**AN ORDINANCE AUTHORIZING A SPECIAL  
USE WITH VARIATIONS FOR COMMUNITY BANK OF DOWNERS GROVE  
TO PERMIT CONSTRUCTION OF  
A TWO-STORY RETAIL BANKING FACILITY WITH A DRIVE-THROUGH**

Commonly known as 1111 Warren Avenue, Downers Grove, Illinois (PIN 09-08-121-003,-004)

## PLANNING & COMMUNITY DEVELOPMENT / STAFF DEVELOPMENT TEAM REPORT

**TO:** Joseph P. Skach, AIA, AICP, Director of Planning & Community Development  
**FROM:** David H. Barber, P.E., Director of Public Works *DHB*  
**BY:** Michael D. Millette, P.E., Asst. Director of Public Works – Engineering *M.D.M.*  
Jonathan C. Hall, P.E., Development Engineering Manager *JH*  
**DATE:** June 14, 2004  
**RE:** Planning / Zoning Request  
Revised Documents Community Bank  
Public Works Department **Final Review (3<sup>rd</sup>)**

**SITE UTILITY PLAN**  
**COMMUNITY BANK OF DOWNERS GROVE**  
 1111 WARREN AVENUE  
 DOWNERS GROVE, ILLINOIS

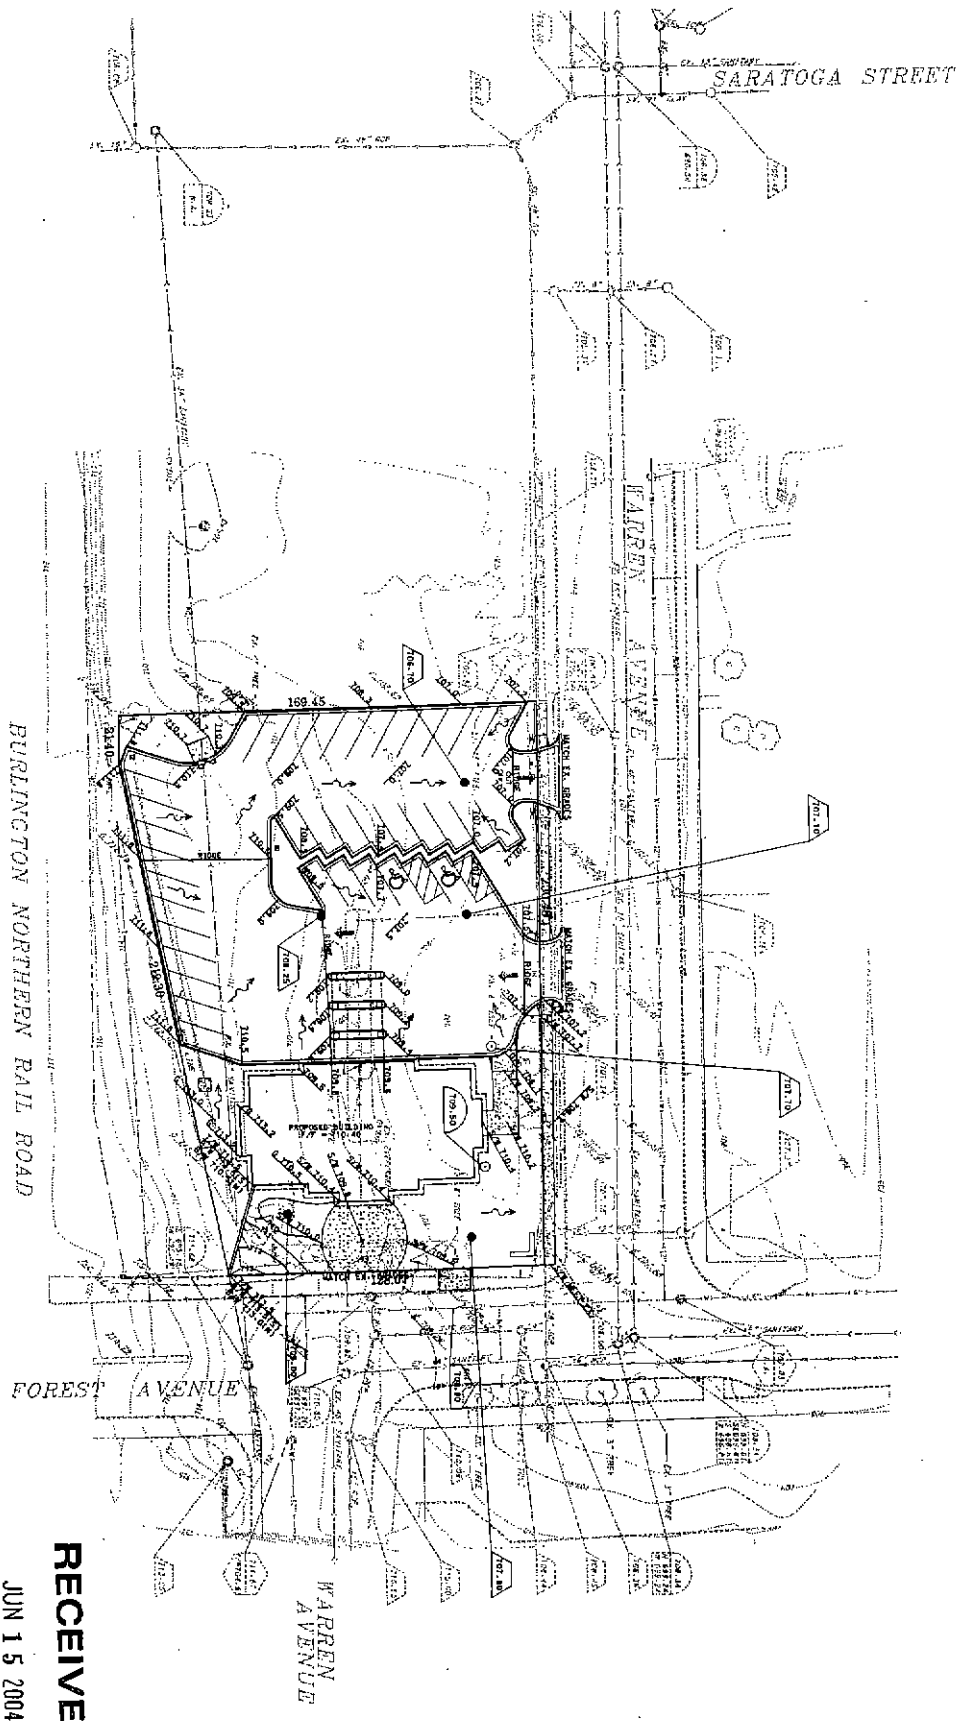
2. Water main located on Warren Avenue is 12" and the water main on Forest Avenue is also a 12". The Utility drawing shows 6" on both streets
3. The 6" pressure tap on Warren is ok. The valve must be a resilient wedge type with stainless steel bolts.
4. The Valve must be in a 72" valve vault due to the size of the water main on Forest Ave.
5. The 2" tap for domestic water to the building can be tapped off the 6" fire line with the B-Box located in the R.O.W.
6. The Existing Building on the lot has an existing water service that must be disconnected at the main on Warren before the building can be demolished.
7. The water main must be a class 52 ductile iron and be poly wrapped.

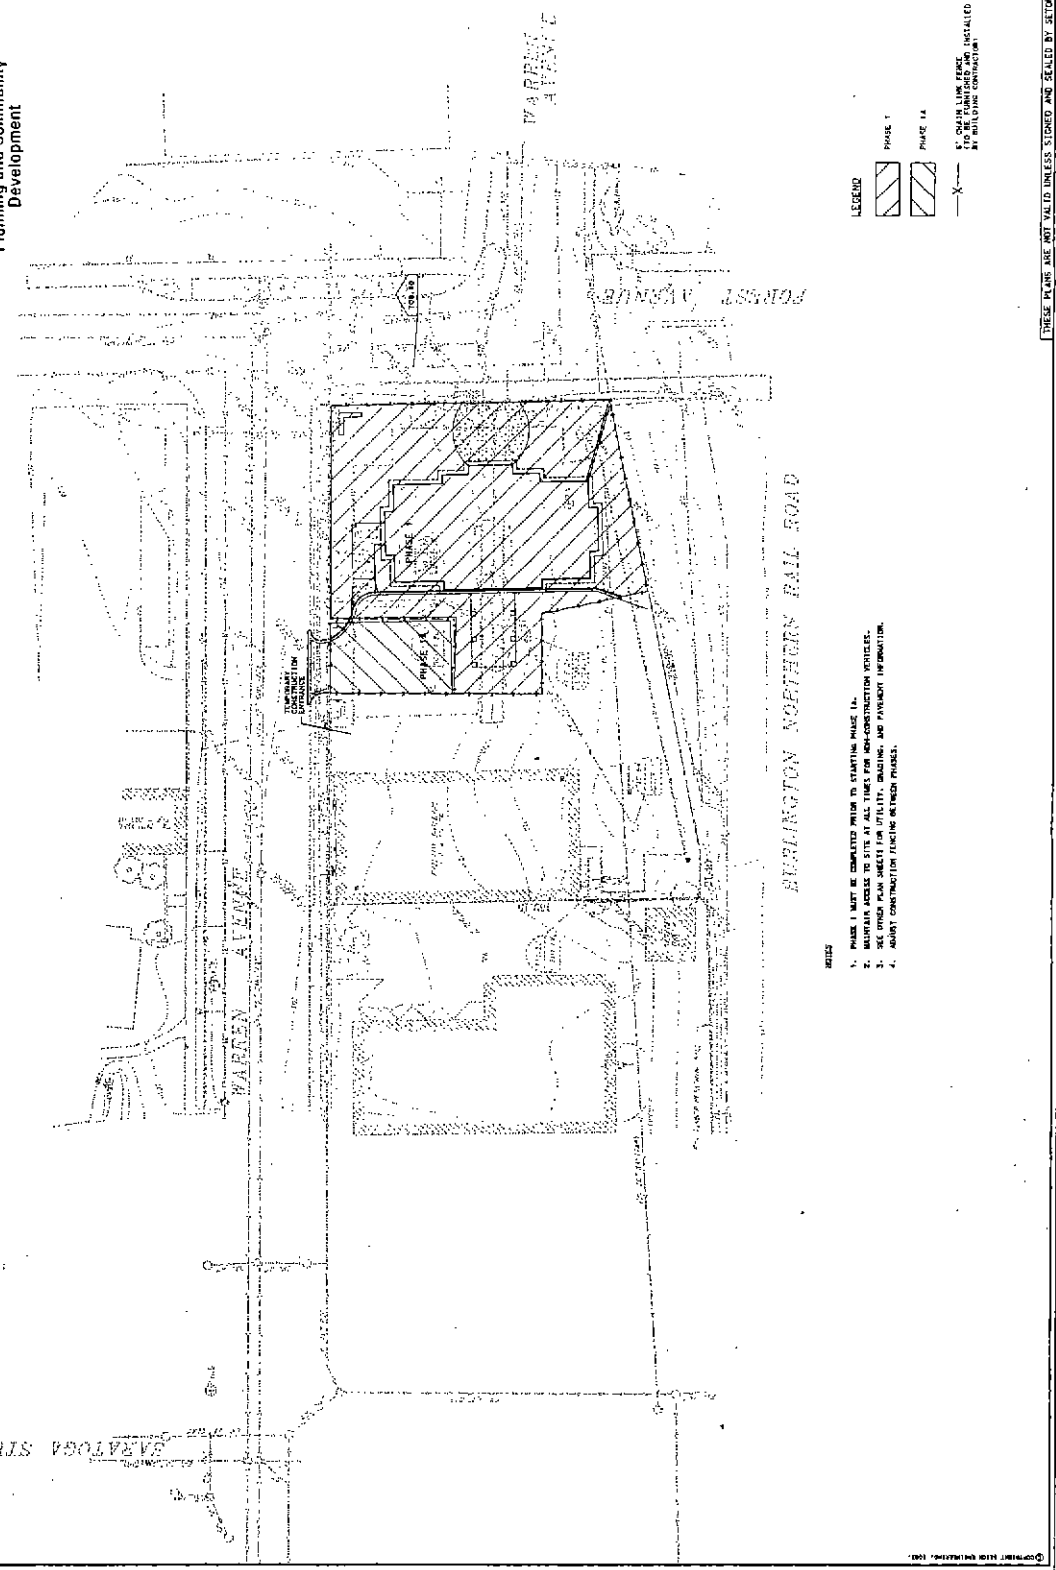
In addition, in the second paragraph of John Hall's comments, he states that underground chambers will likely be required to provide for the compensatory excavation quantity. If you refer to drawing C5 in the most current submittal, Seton Engineering has already provided a "Stormtrap Structure" that is 45'x 45'x 4' deep in the northern portion of the parking lot that does drain to the existing 48" RCP which runs parallel to Warren Avenue.
